**Response to Comments
Review of Site-Specific Cleanup Goal Report
Former Kast Property, Carson, California**

SUBJECT: REVIEW OF REVISED SITE-SPECIFIC CLEANUP GOAL REPORT AND DIRECTIVE TO SUBMIT REMEDIAL ACTION PLAN, HUMAN HEALTH RISK ANALYSIS, AND ENVIRONMENTAL ANALYSIS FOR CLEANUP OF THE CAROUSEL TRACT PURSUANT TO CALIFORNIA WATER CODE SECTION 13304

**Comments from the Expert Panel on the
Revised Site-Specific Cleanup Goal Report
Submitted: December 18, 2013**

Summary of Trichloroethene Concentrations in Soil		Figure E-1
Former Kast Property		
		E-1
Santa Barbara	October 2013

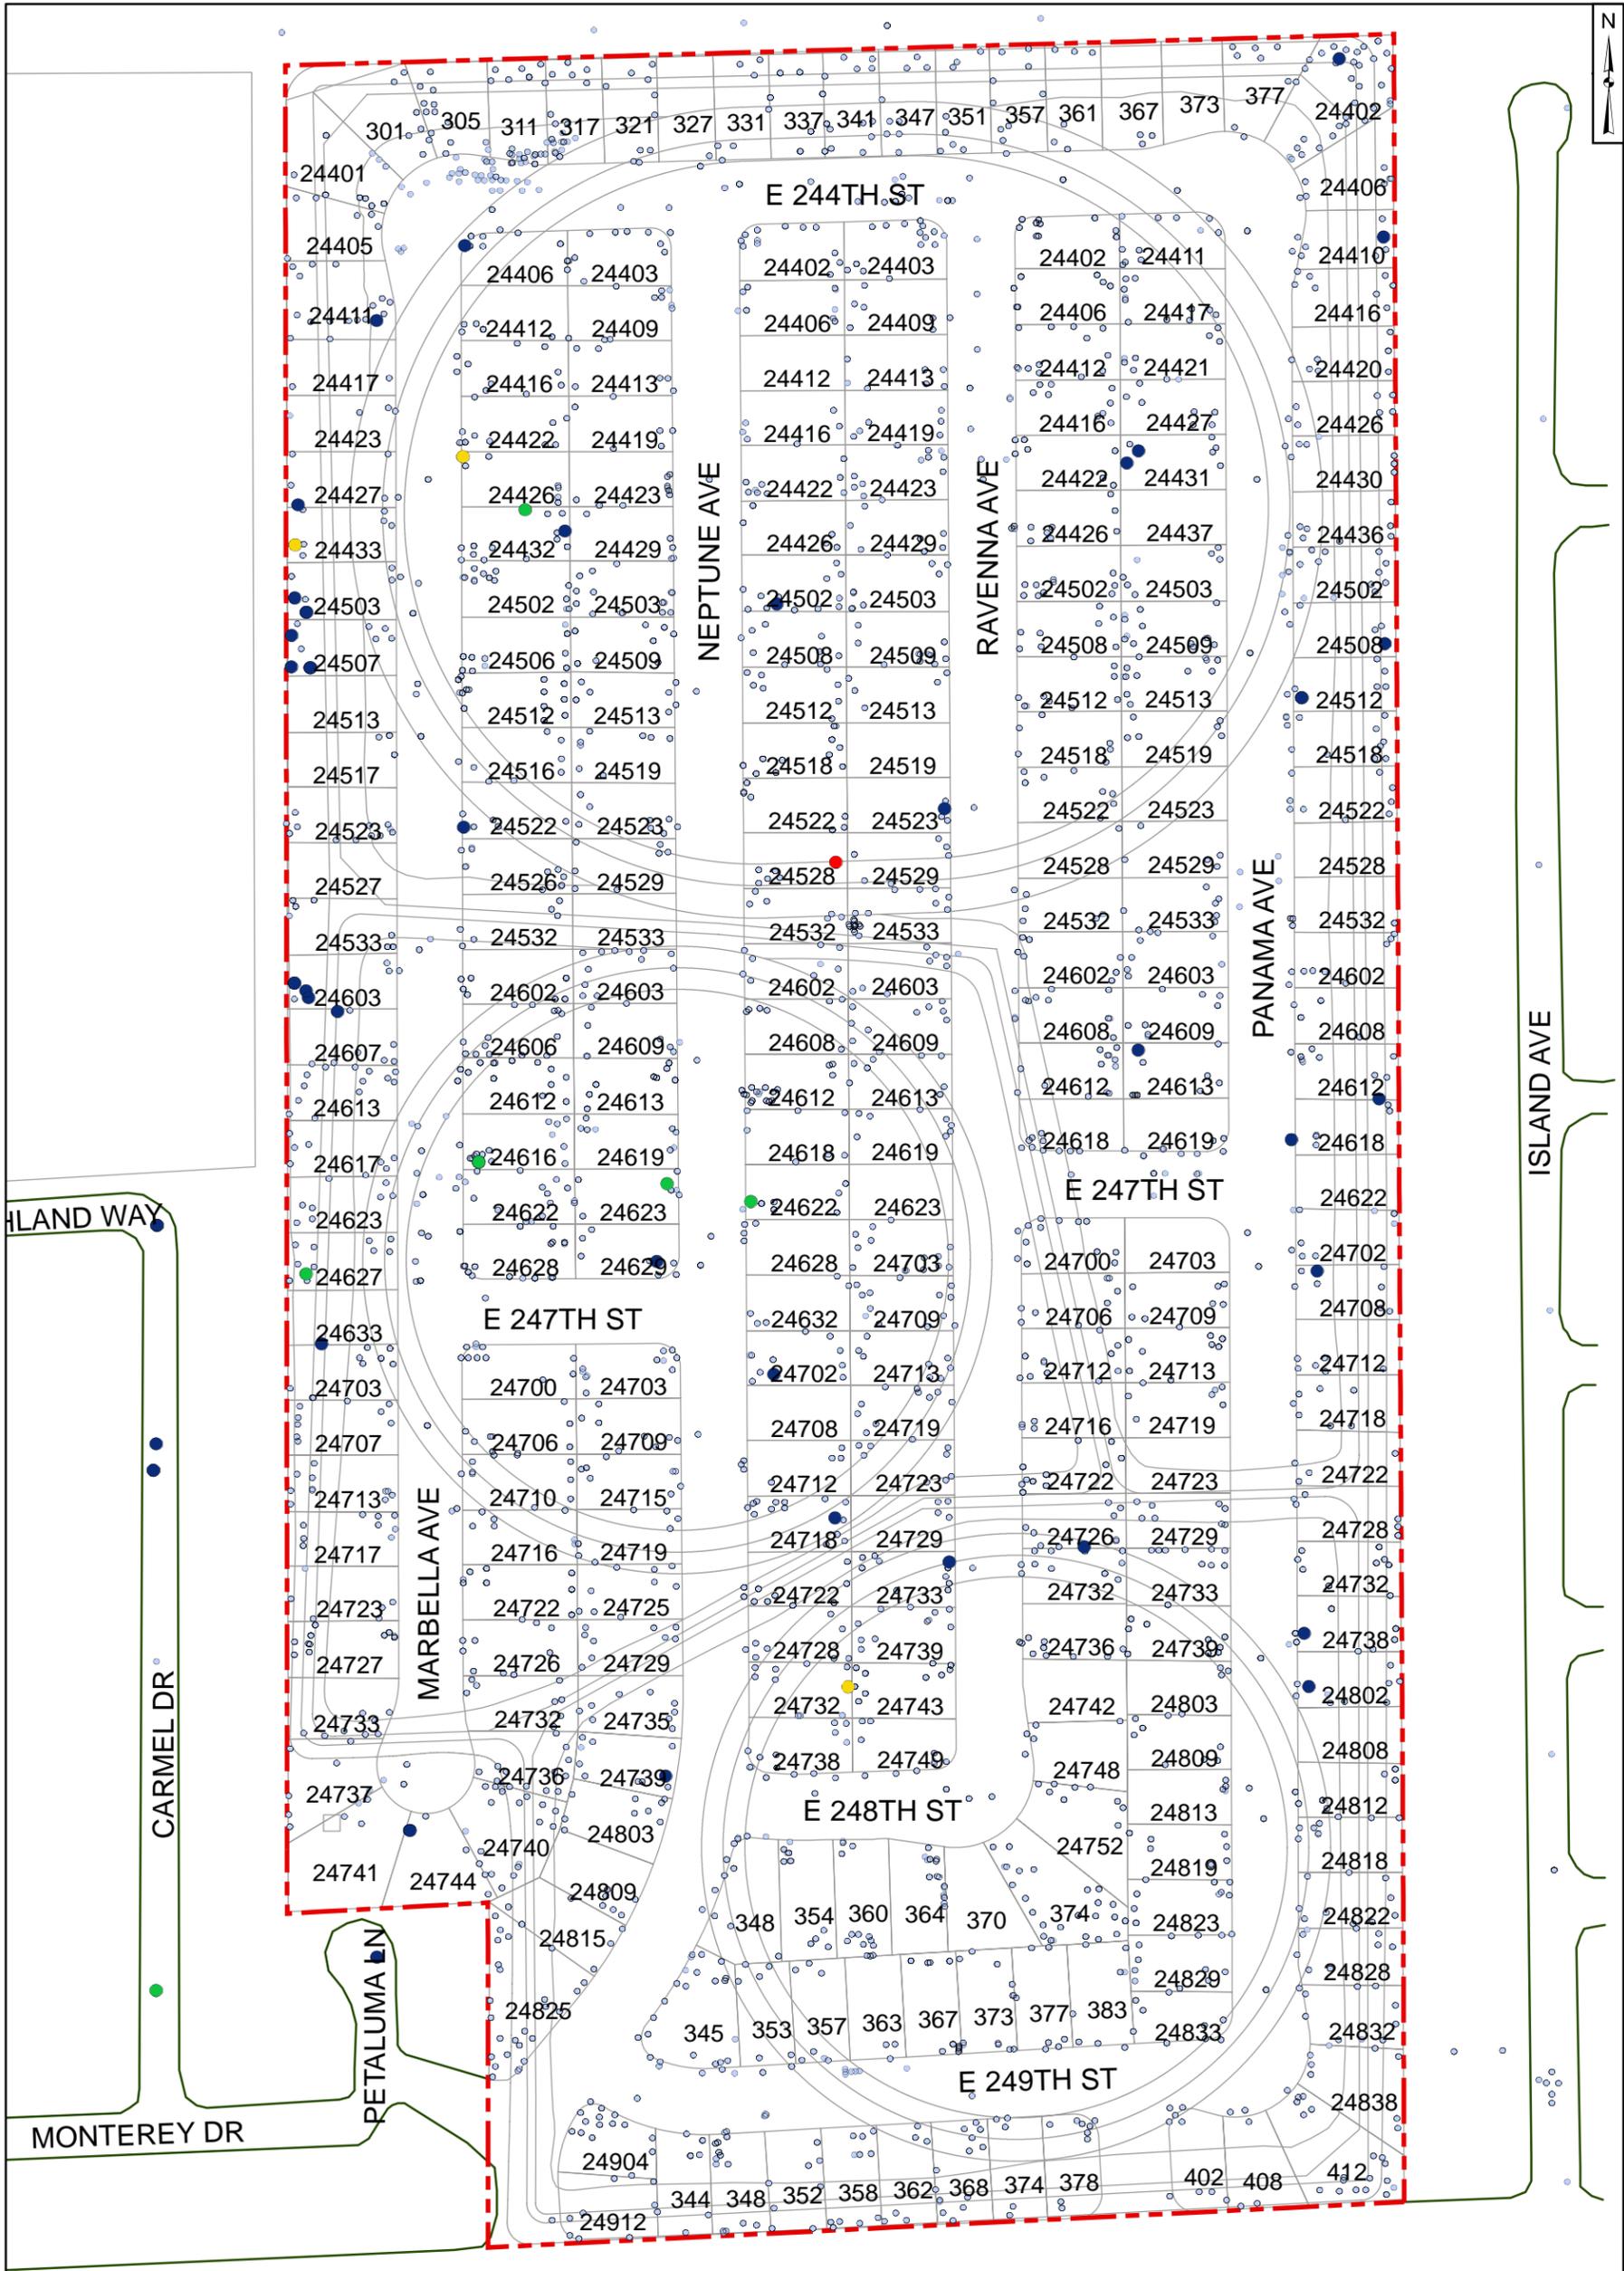
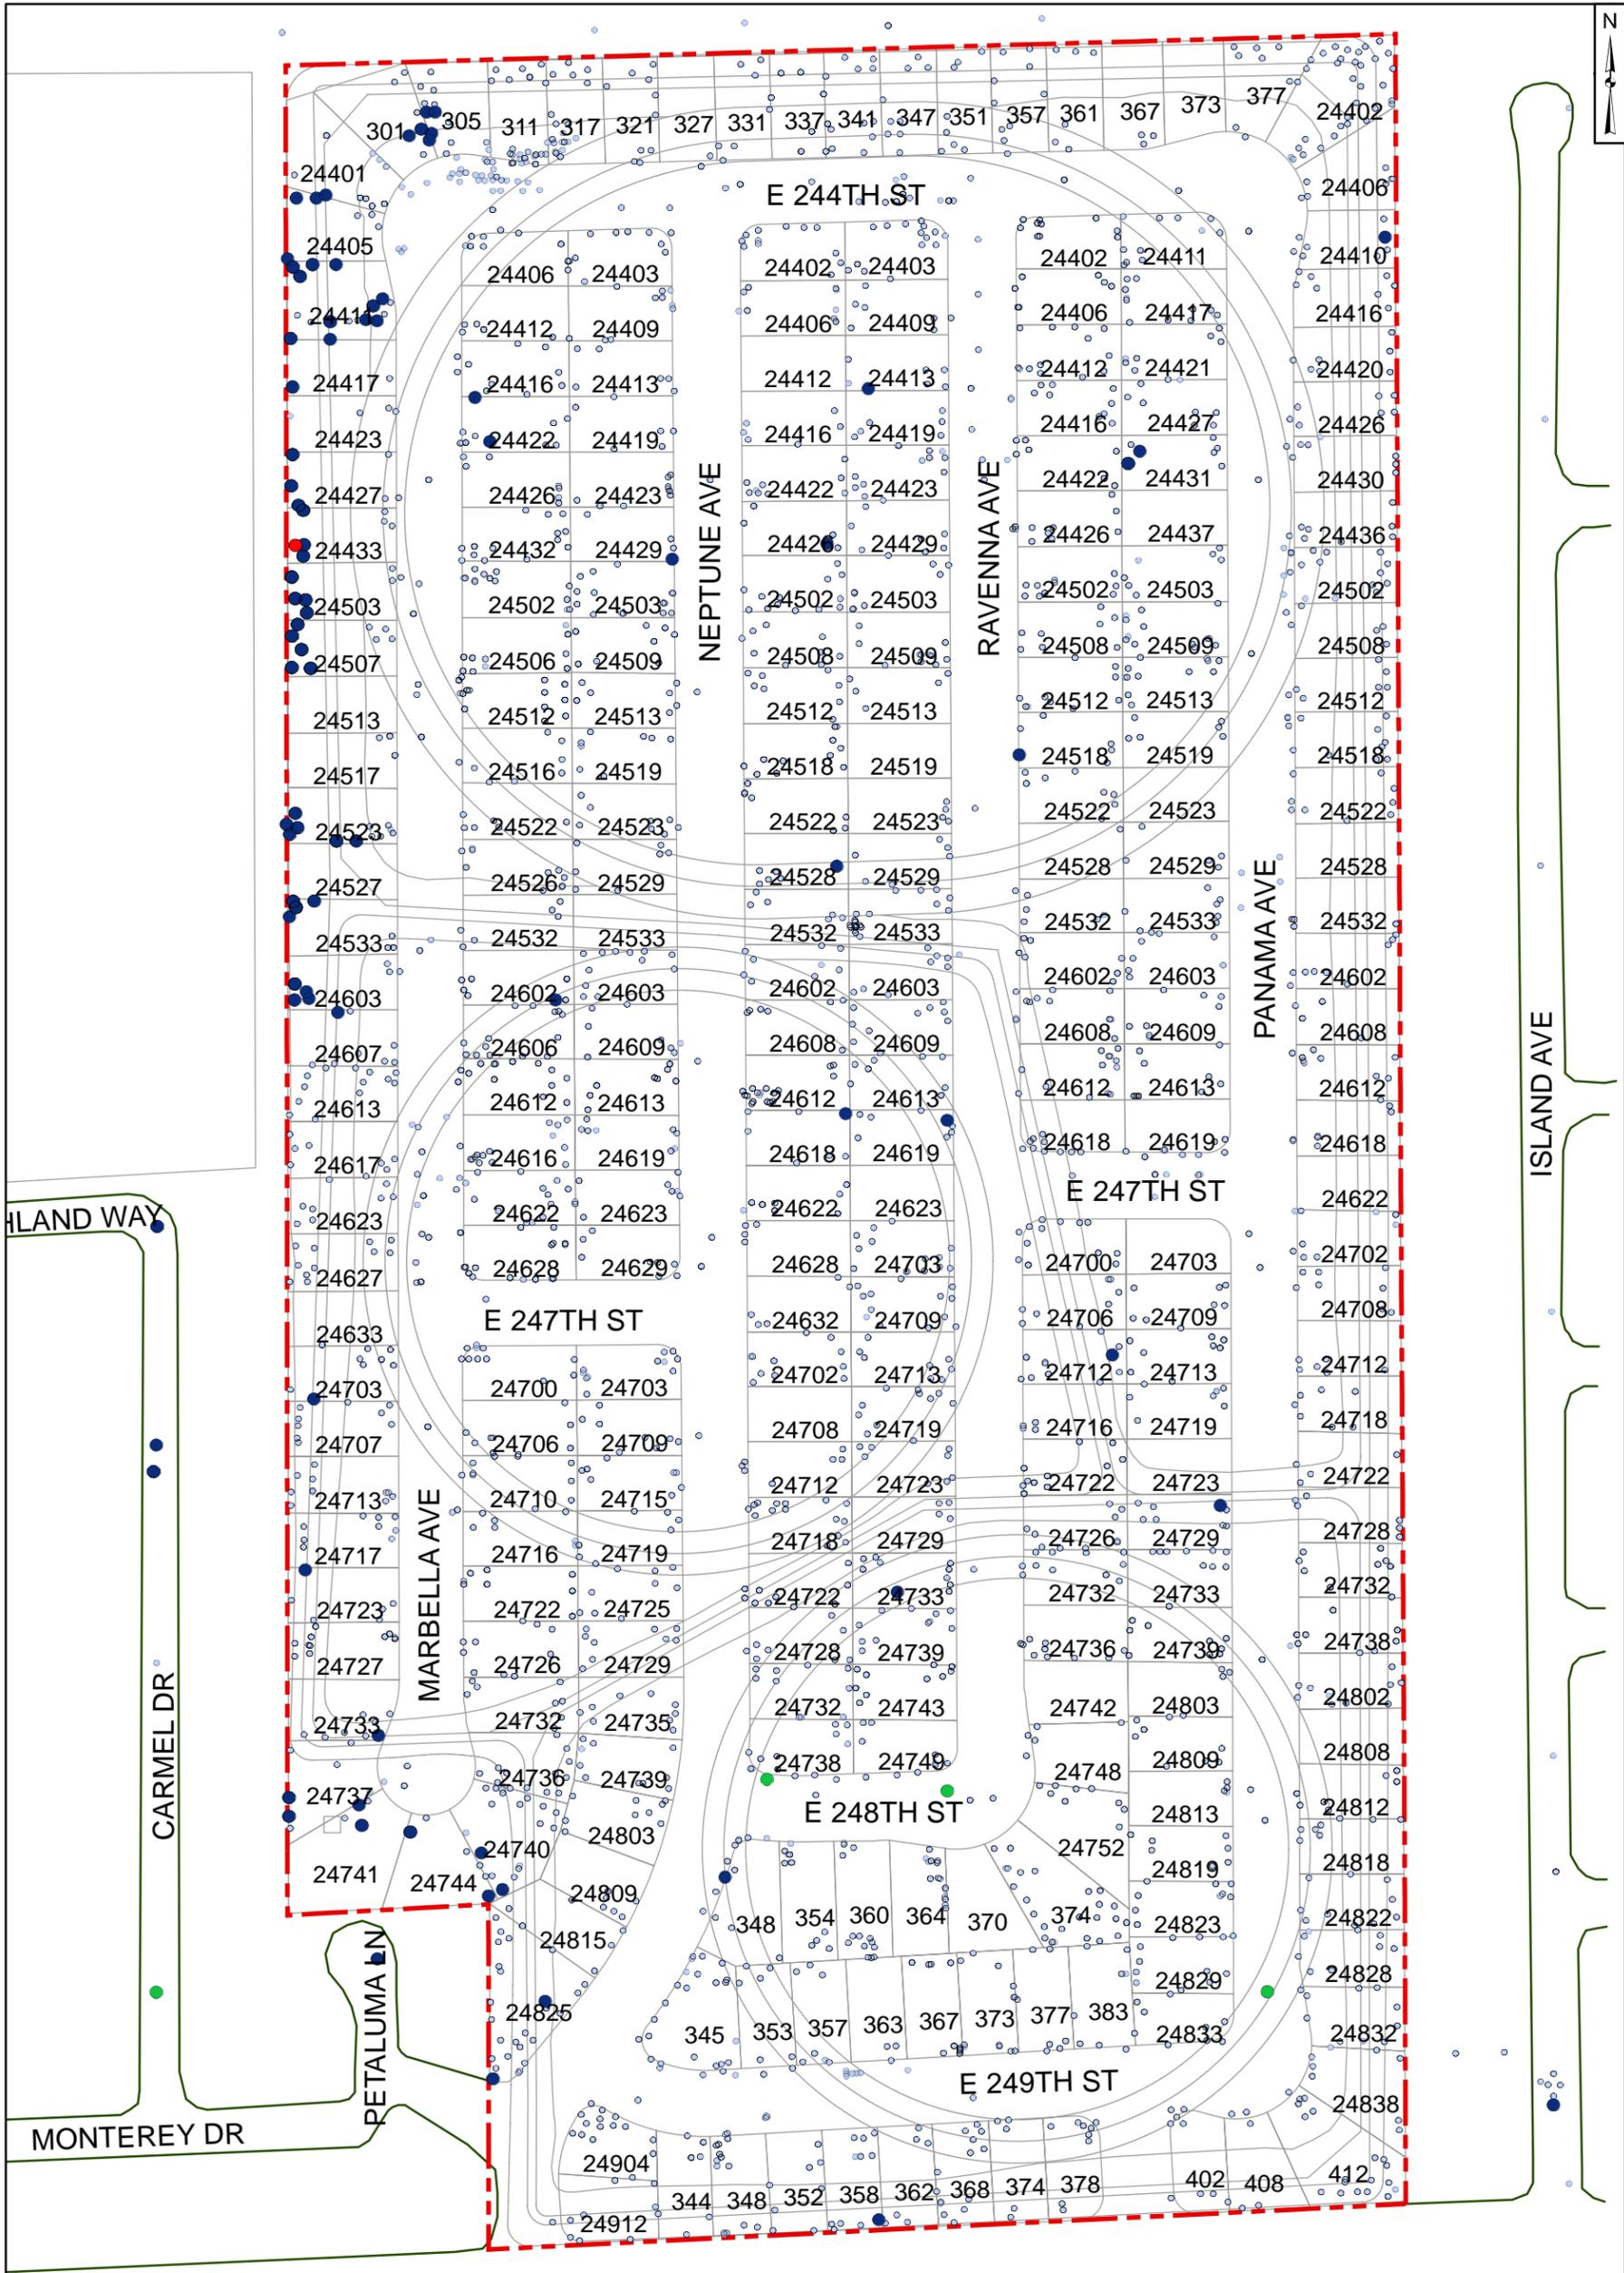
Expert-27	Page 13 CVOC sources -Second Paragraph	<p><i>Lack of maps for CVOCs hinder ability to better understand their distribution and thus sources and risks. There is an emphasis on only considering petroleum-based COCs, even though data is available for many other COCs. Most of the CVOC data is only presented in tables and not considered in some of the analyses, which is not</i></p>	<p>See response to Comment RWQCB-2. SSCGs are presented for all COCs regardless of whether they are Site-related or not. CVOCs will be addressed in the RAP. Maps illustrating the distribution of PCE and TCE in groundwater have been added to the report</p>	Section 2.1.2 Section 8.3.1 Appendix E. Section 9.4

Geosyntec provided in Appendix E the distribution maps of PCE and TCE in both shallow soil and in groundwater. These maps make the best case for the conclusion that the CVOCs in both shallow soil and groundwater are from neighboring source, but the evidence could be presented more clearly and transparently. The "evidence" of "[T]he lack of detections of PCE and TCE in Site soils between 10 feet below ground surface and groundwater (>400 samples)" [Response to comment RSQCB-2] does not "rule out" that CVOCs in shallow soil are sourced from the Site rather only rules out that the Site probably did not source the groundwater plume under the site. We advise the Regional Board to focus attention on this area.
